Application for Development Permit in River Landing

Remai Art Gallery of Saskatchewan

APPLICATION NO. PL 4129-11	PROPOSAL Application for Direct Control District Approval – Remai Art Gallery of Saskatchewan	EXISTING ZONING DCD1
LEGAL DESCRIPTION Parcel X, Plan No. 101856427		CIVIC ADDRESS 102 Spadina Crescent East
		NEIGHBOURHOOD Central Business District
DATE December 7, 2011	APPLICANT Grant Van Iderstine Smith Carter Architects & Engineers Incorporated 1600 Buffalo Place Winnipeg MB R3T 6B8	OWNER City of Saskatoon

East View - Main Entrance

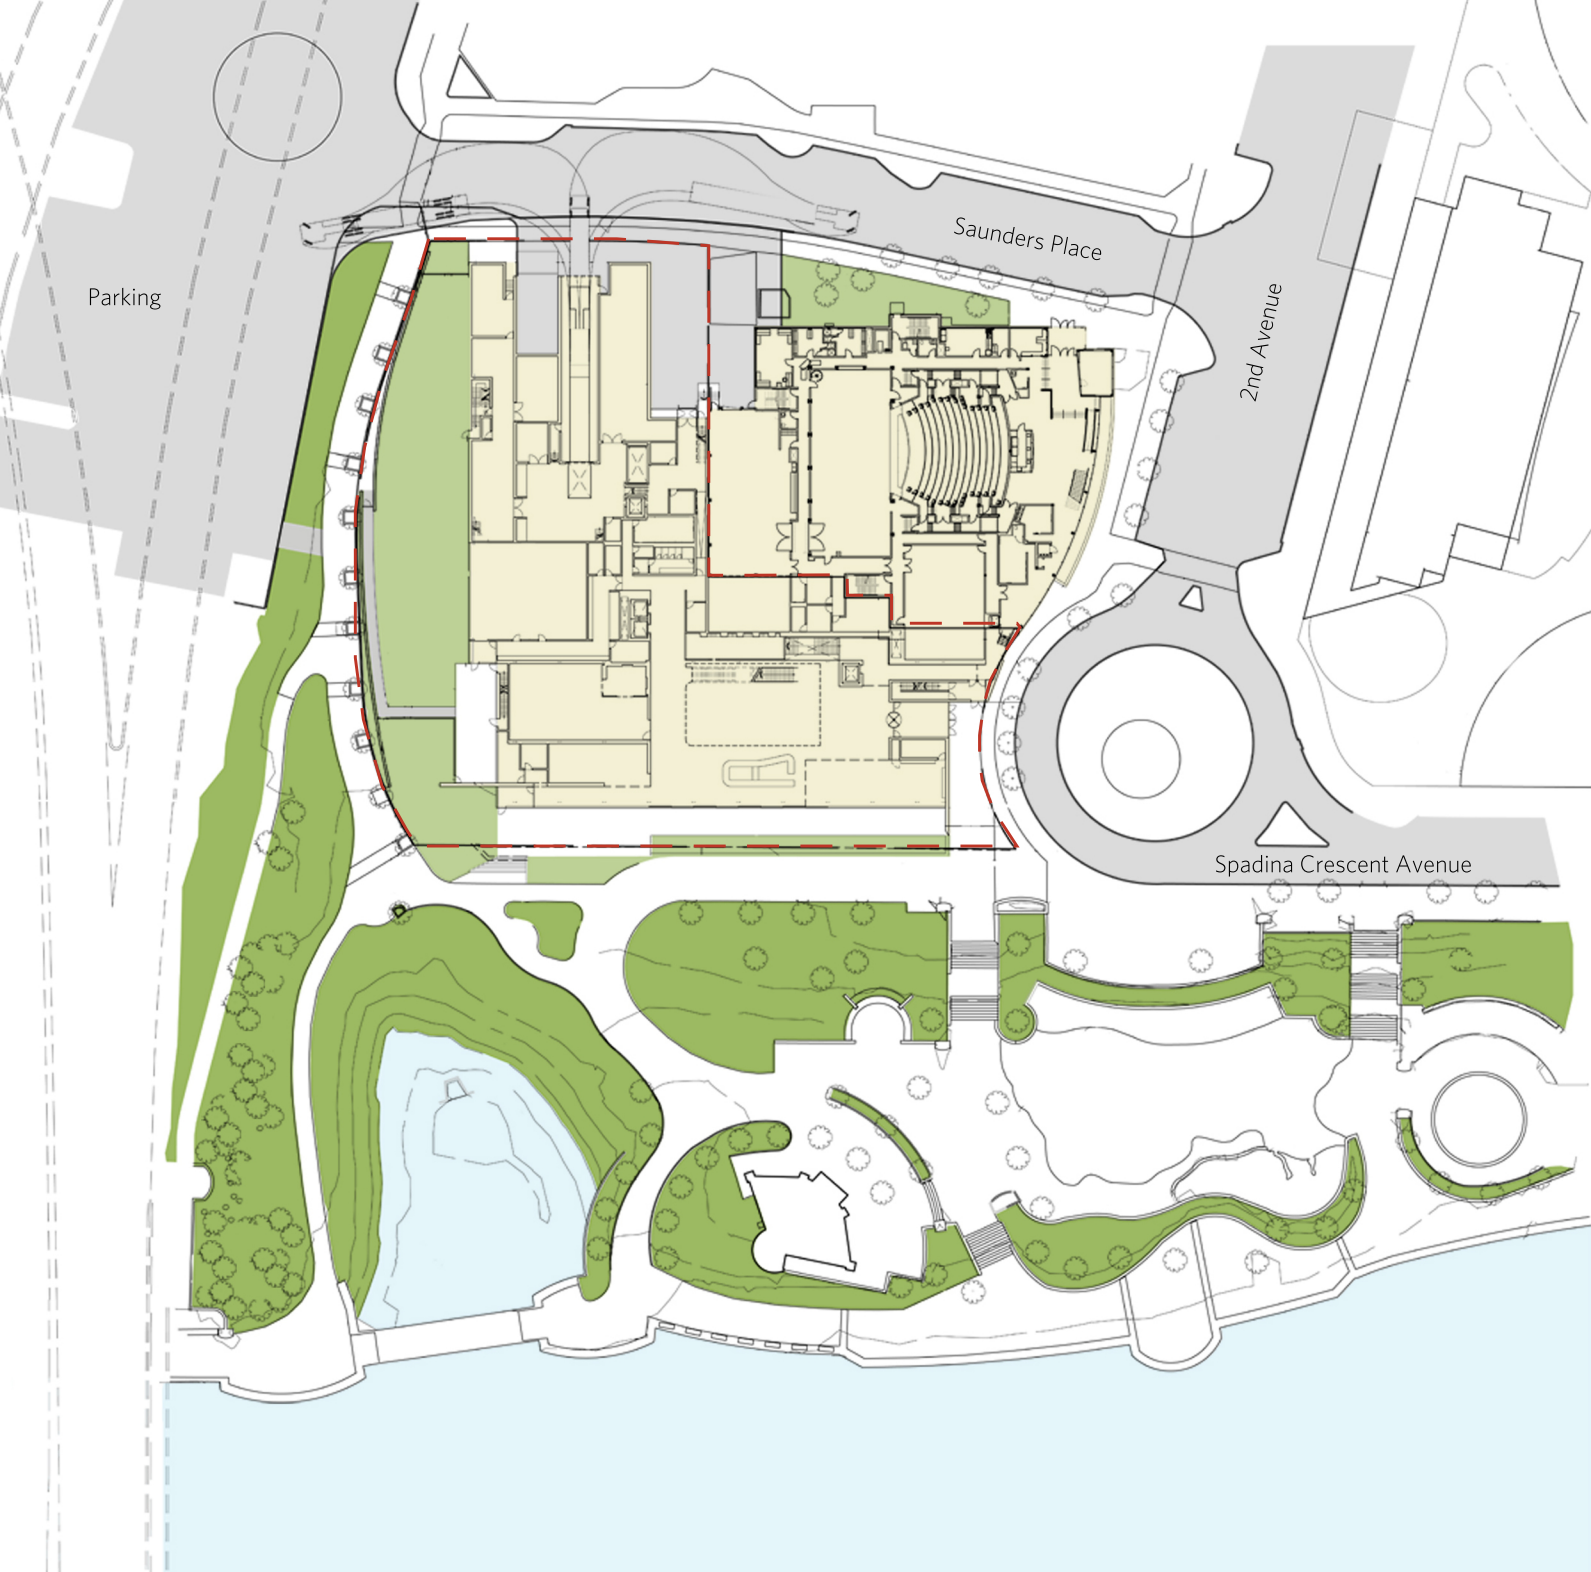
The Committee is of the opinion that this development is well designed. It was noted by the Committee that this site is challenging due to the shape of the site and the limited frontage onto 2nd Avenue South. On this basis, the Committee recommends approval of the Concept Plan for the Art Gallery of Saskatchewan subject the following conditions:

1. The submission of a wind study and plans for landscaping, architectural, or other features, which may be required to mitigate any wind effects.
2. Amendments to the design of the building to eliminate the grade level encroachment onto the 2nd Avenue South right-of-way.

3. The submission of details regarding roofing materials, including the green roof and wooden decking, and roof drainage.
4. The submission of renderings, which accurately represent the sample materials, as they were provided on the material board and clarification of the materials to be used on the north building elevation.

5. The submission, in due course, of an appropriate application and detailed drawings for building signage.
6. The submission of additional information regarding the impact and possible mitigation measures related to headlights from vehicles exiting the parking structure or services vehicles parked at the open-air loading dock on residential units in Clinkskill Manor.

7. The submission of additional information and possible mitigation measures related to the impact of noise generated by the rooftop mechanical systems on nearby residential and hotel developments.

1. The landscape plan shows distinctive (new) paving on the east frontage of the building along the edge of the roundabout at the termination of 2nd Avenue South. Distinctive pavers could be restricted to the area leading to the front entrance, directing pedestrians to the entrance to the art gallery.
2. There is no glazing facing Saunders Avenue. The lack of glazing limits “eyes on the street” on Saunders Avenue. It is recognized that this is the back house of the gallery and the

loading area, so there may be limited opportunities for glazing on this facade of the building.

3. The landscaping plan proposes the use of perennials. These plants require significant maintenance. Consideration should be given to using hardy, drought tolerant shrubs as they require little maintenance beyond the establishment phase. Consideration should also be given to installing an automated sprinkler system at least during the establishment of the plantings.
